FINAL ENVIRONMENTAL IMPACT REPORT – Volume 3

Biosolids Digester Facilities Project

PLANNING DEPARTMENT
CASE NO. **2015-000644ENV**

"2. Impacts of Other Project Components - Display Building

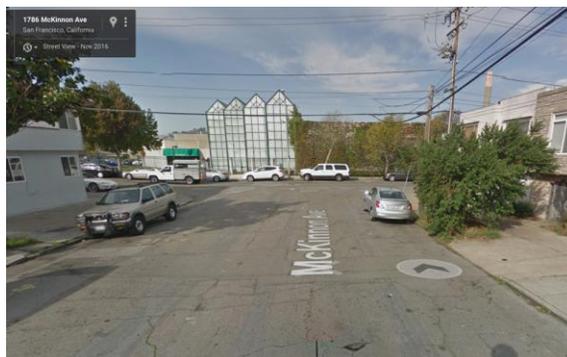
"The most prominent features of the greenhouses are four tall, narrow structures near the edge of the property on Phelps Street. As a separate action from the BDFP, the San Francisco Public Utilities Commission(SFPUC) plans to demolish the existing structures at the Southeast Greenhouses site (refer to Table 4.1-1 in Section 4.1). The site would be used for construction staging for the project if it becomes available prior to BDFP construction.'

"The smaller, yet taller, glassed in greenhouse 'facade' - THE DISPLAY BUILDING is a striking and important community marker at the intersection of Phelps and McKinnon Avenues. As community planners and advocates for improving the physical environment where we live, the potential for losing these smaller buildings (if contemplated in Phase 1) seems antithetical to the goals we've set for ourselves in lifting this place in Bayview.

Regarding the display greenhouses, the Southeast Greenhouse Demolition project is a separate project previously approved by the SFPUC, which the Draft EIR considered in the analysis of cumulative impacts. As stated in Draft EIR Table 4.1-1 (page 4.1-10), the Southeast Greenhouse buildings, which include the display greenhouses, were constructed in 1986 and are not historic structures. Refer also to **Response OC-3** in Section 10.9 of this document.

2. Impacts of Other Project Components - **Display Building**

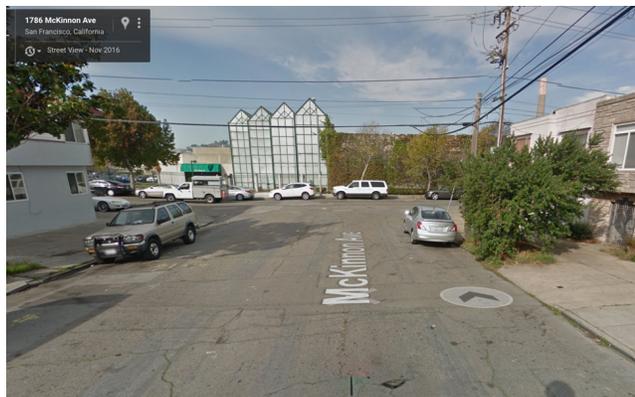
'The most prominent features of the greenhouses are four tall, narrow structures near the edge of the property on Phelps Street. As a separate action from the BDFP, the San Francisco Public Utilities Commission(SFPUC) plans to demolish the existing structures at the Southeast Greenhouses site (refer to Table 4.1-1 in Section 4.1). The site would be used for construction staging for the project if it becomes available prior to BDFP construction.'

SFPUC Biosolids Digester Facilities
Figure 2-15
 Construction Haul Routes

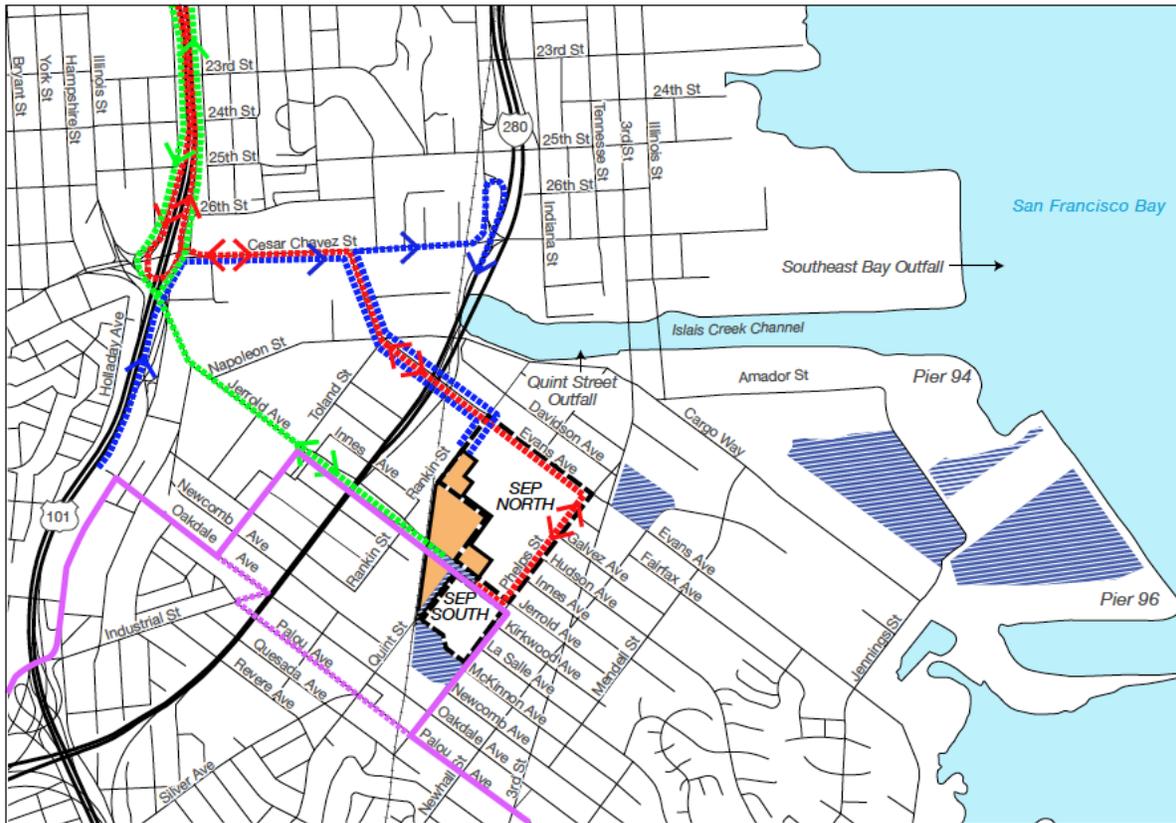
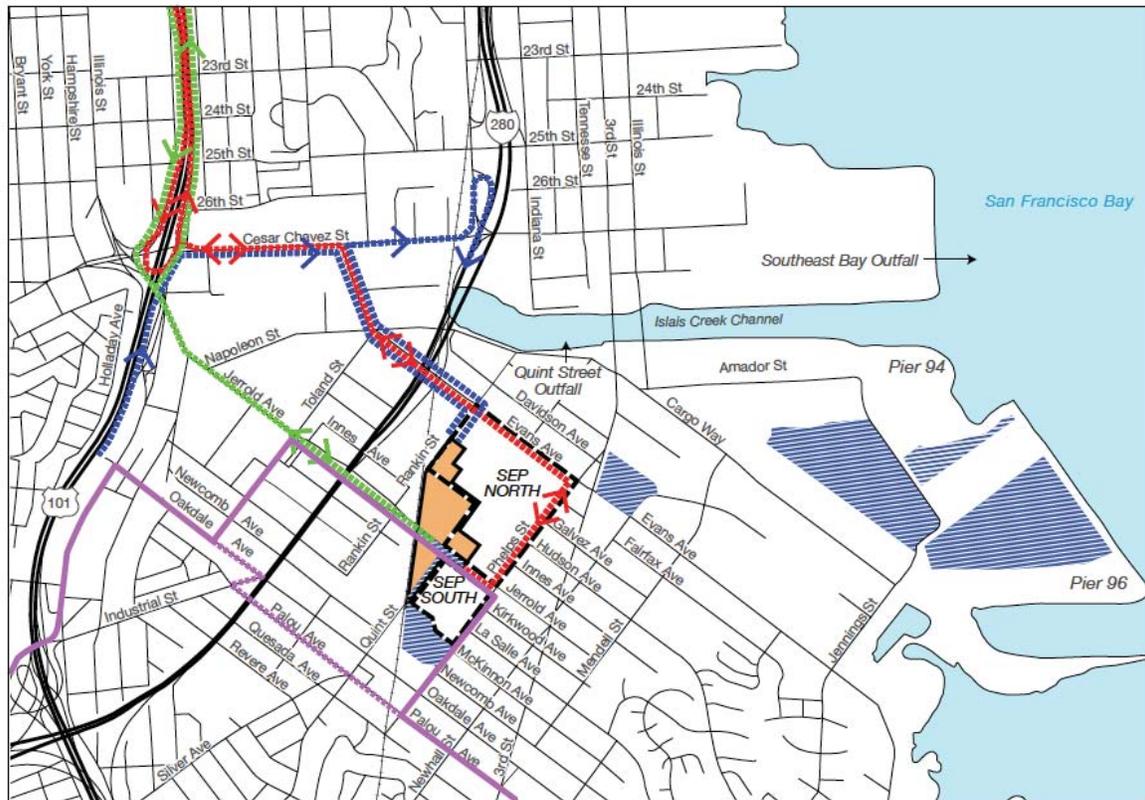
3. Reconsideration of the temporary relocation of Muni 23 Monterey Bus line. SFPUC, with SFMTA as lead agency, to consider the cumulative impact of the Jerrold Street closure, the streetscape improvement project on Palou Avenue, the narrowing of Evans Avenue, and the heavily impacted Oakdale Avenue arterial due to the above concurrent projects.

Regarding the potential for dust from off-site transport, as shown on Draft EIR Figure 2-15 (Draft EIR page 2-60), only incoming (unloaded) trucks would use Jerrold Avenue through the produce market. Outgoing (loaded) trucks would use Rankin Street, Evans Avenue, and Cesar Chavez Street for access to either U.S. Highway 101 (Highway 101) or Interstate 280, and would not pass through the produce market. Further, in accordance with the Dust Control Ordinance, the amount of soil in hauling trucks would be limited to the size of the truck bed and walls, and trucks hauling loose materials (e.g., soil and sand) would be covered with a tarpaulin or other effective cover. With implementation of these measures, there would be no significant dust generation along the haul routes associated with the hauling of waste materials from the BDFP site.

SAN FRANCISCO WHOLESAL PRODUCE MARKET
AND NEIGHBORING PROJECTS

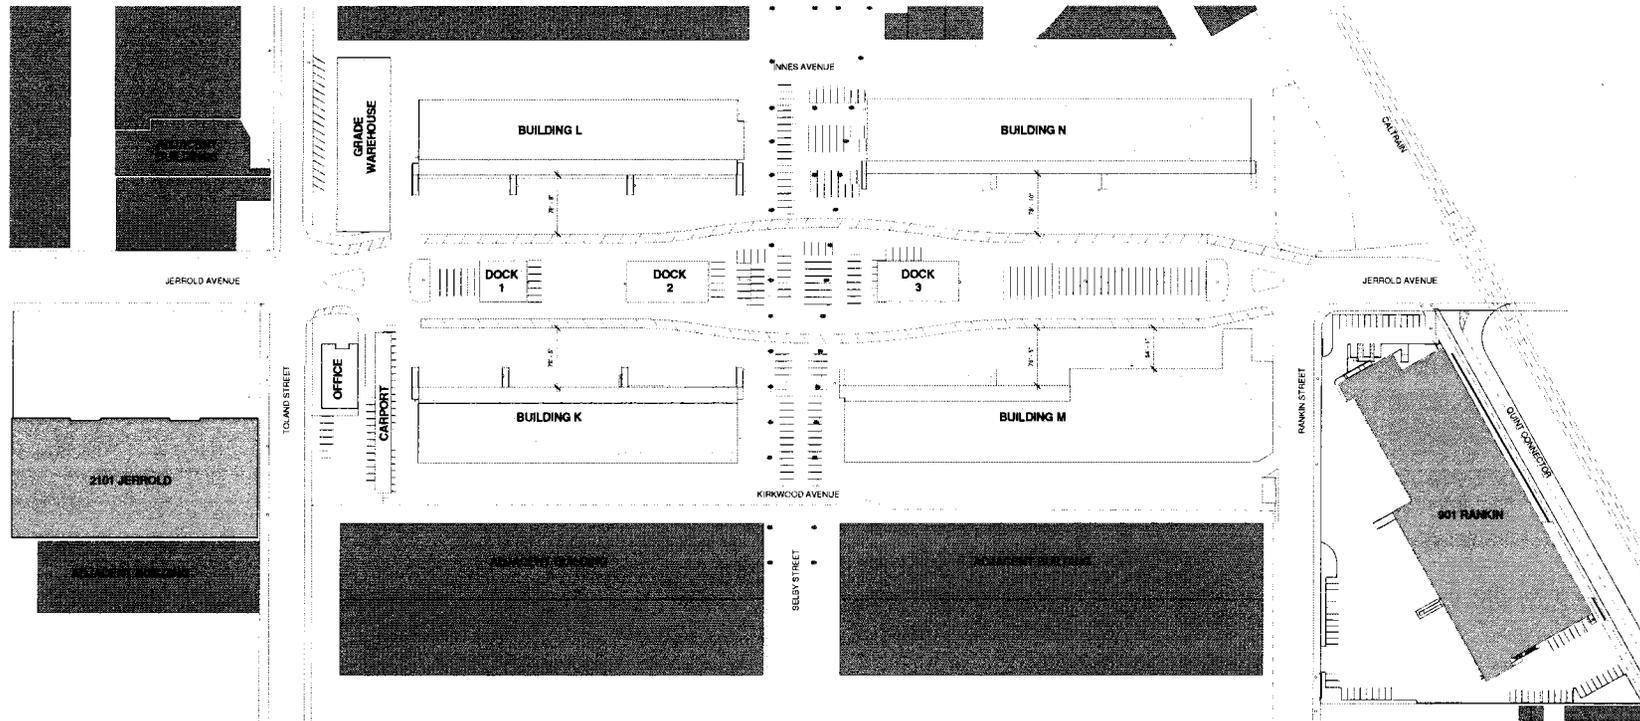
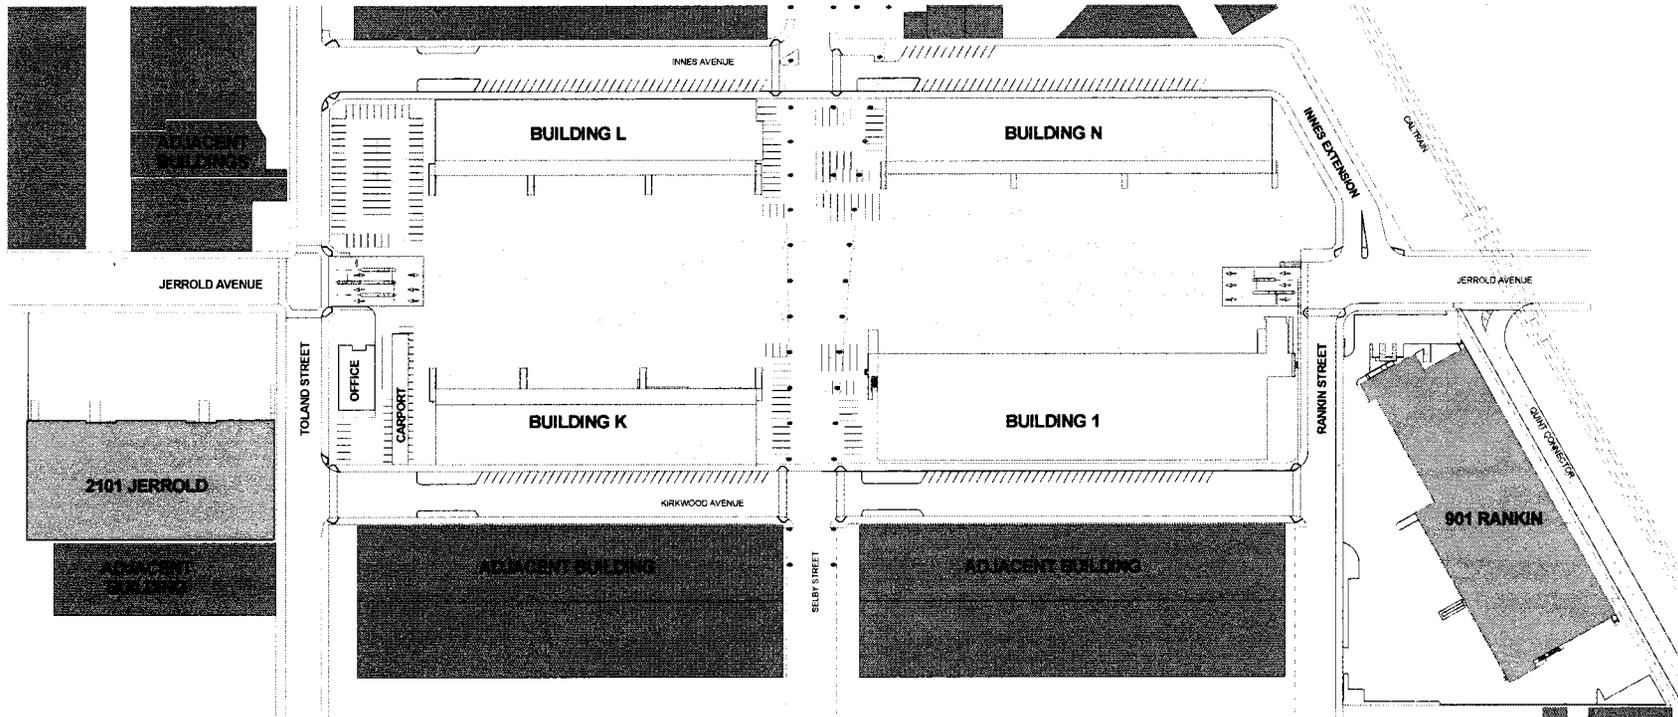
O-SFWPM-1.4

The produce market also requests that the design of its planned improvements to Innes Avenue be coordinated with the BDFP, and included in the BDFP Draft EIR project description. However, as presented on Figure 2-12 (Draft EIR page 2-48), upon completion of the BDFP construction, all BDFP operational trucks (including chemical delivery, yellow grease loading, and biosolids trucks) would use Evans Avenue for access to the water pollution control plant, and would therefore not travel on Jerrold Avenue or the new roadways required to be constructed by the produce market. The produce market Innes Avenue improvements should not be part of the BDFP project description and no change to the Draft EIR is necessary. Regardless, the SFPUC will continue to coordinate with the produce market on the two projects.
